ROBERT L CLOUD ASSOCIATES, INC.

Docket No. 50-275
Diablo Canyon Unit 1
License No. DPR-76

During the January 31, 1984 NRC public meeting, at PG&E regarding allegations at Diablo Canyon, issues were raised that relate to the IDVP verification of Diablo Canyon small bore piping and supports. Enclosed please find a discussion of these issues. The discussion is intended to clarify the relationship between the NRC issues and the IDVP verification. It includes an amplification of the methods and rationale employed by the IDVP.

RLCA Response to NRC Concerns
of January 31, 1984

DWG. No. 99-11 REV. No. 6

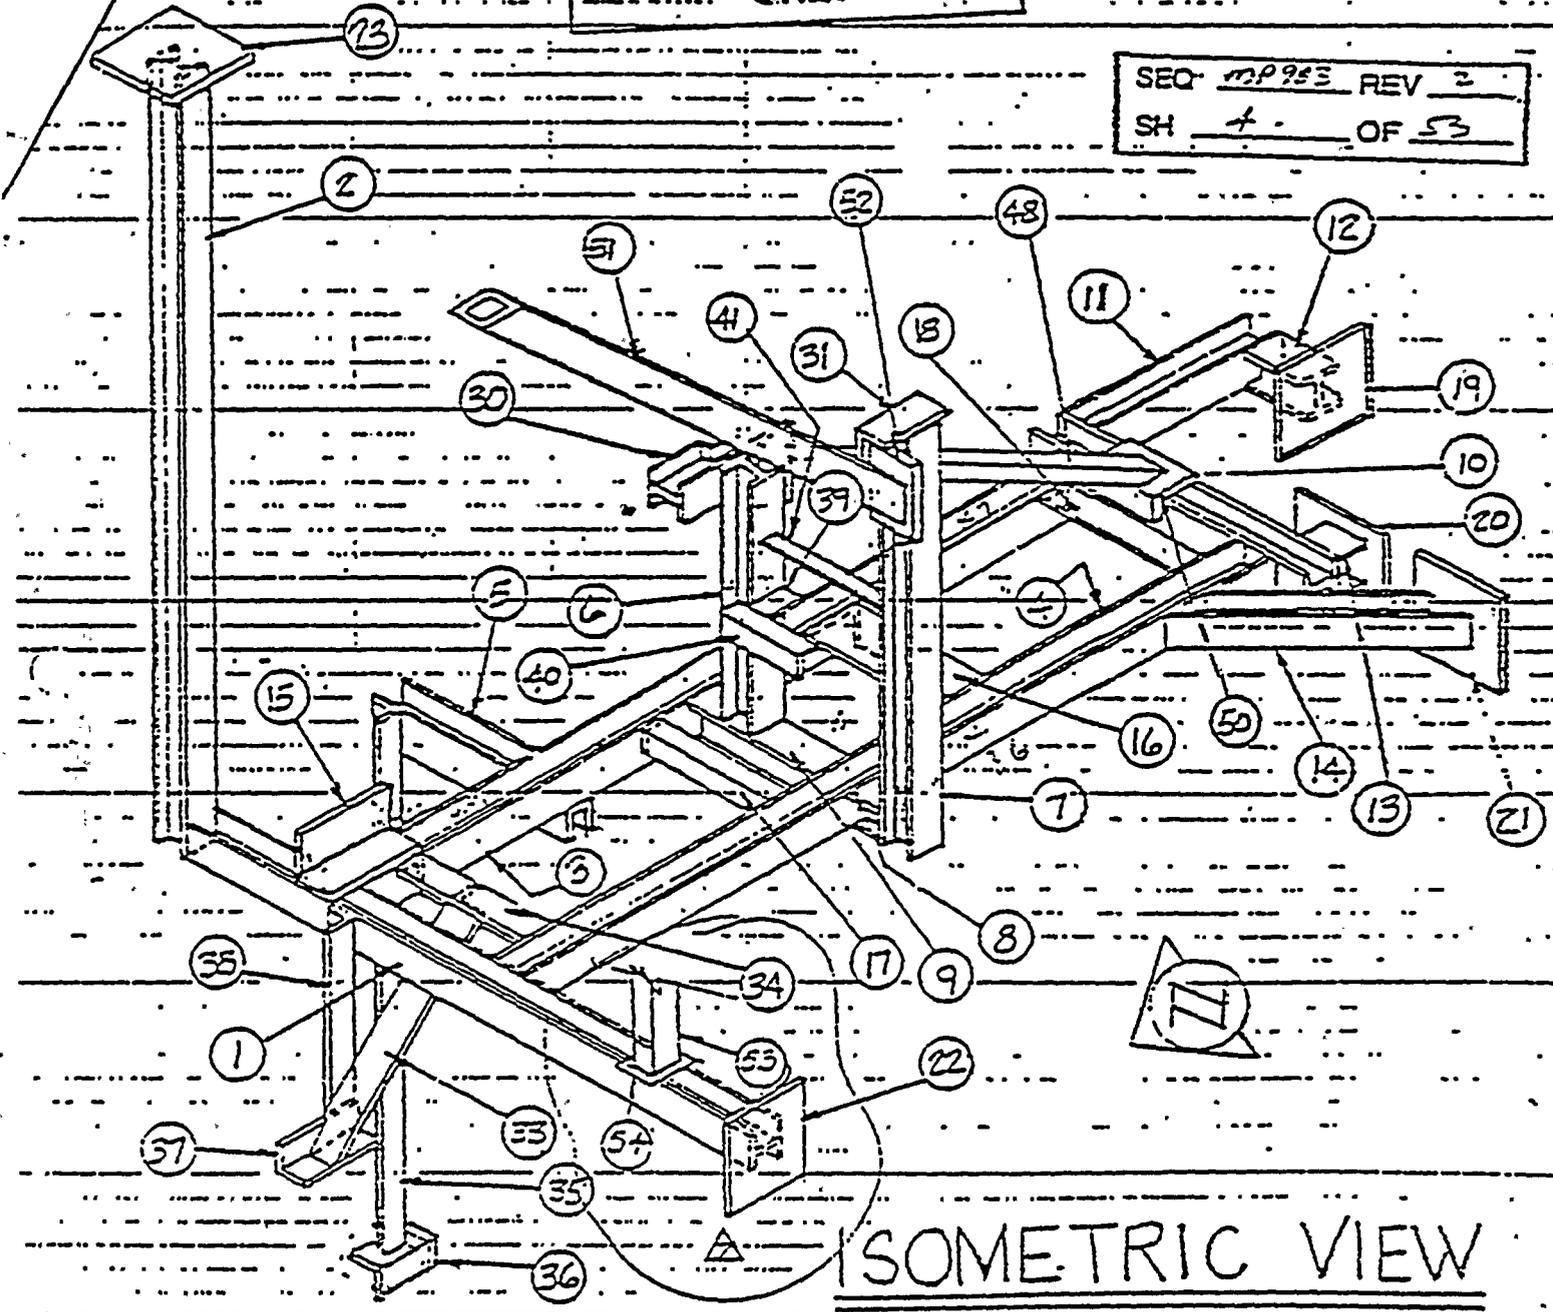
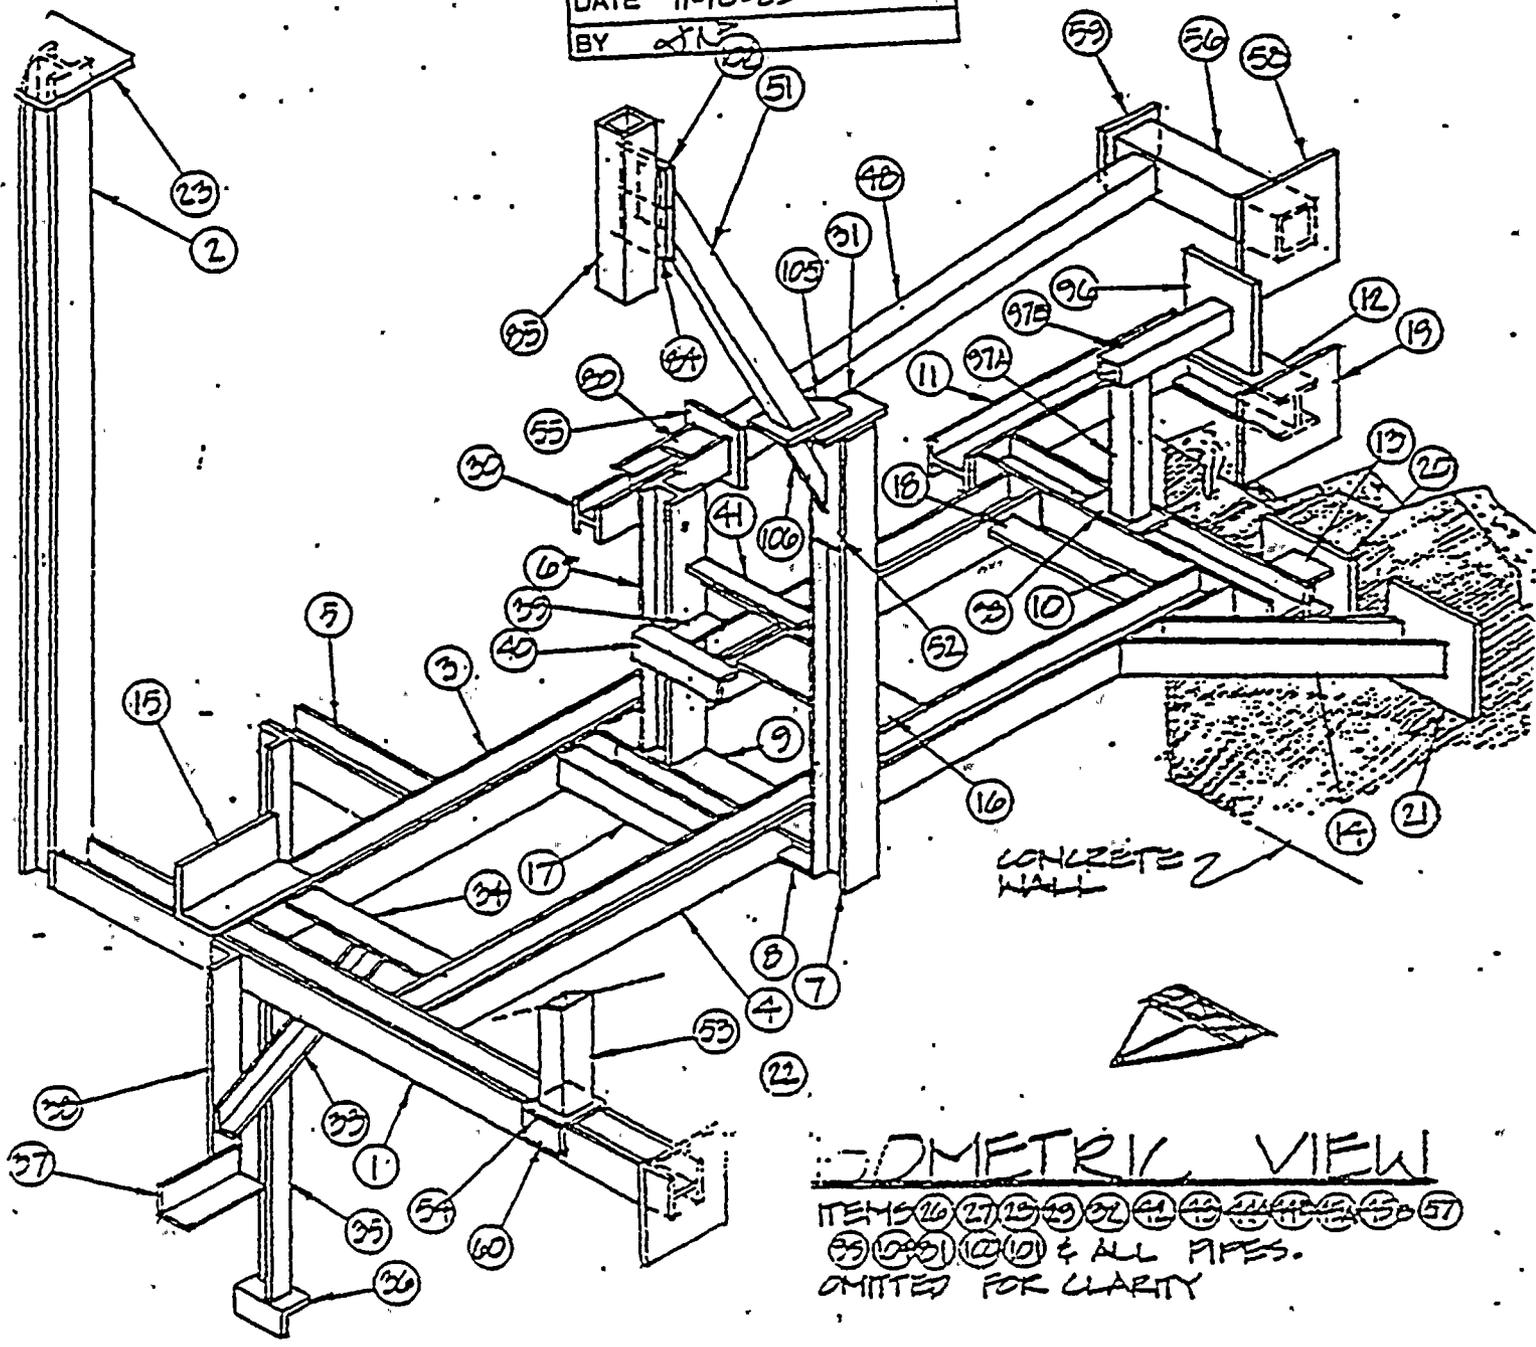
NO.	CALC.	SUPPORT	COMMENT
1	MP 072	2171-16	<u>Design Deficiency, QA Deficiency</u>
2	MP 345	2182-74	OK
3	MP 357	2182-91	OK
4	MP 951	100-111	Deficiency (Review Not Complete).
5	MP 955	99-201	Calc. Deficiency. QA Deficiency.
6	MP 983	99-11	<u>Design Deficiency.</u>
> 7	MP 988	100-132	Modeling Deficiency. Calc. Errors. QA Deficiency.
8	MP 397	H21-226	OK
9	MP 465	002-170	QA Deficiency.
10	MP 942	99-20	Calc. Deficiency. Calc. Error.
11	MP 1621	2156-200	Calc. Error. <u>Design Deficiency.</u>
12	MP 1691	97-90	QA Deficiency.

Problems with 9 out of 12
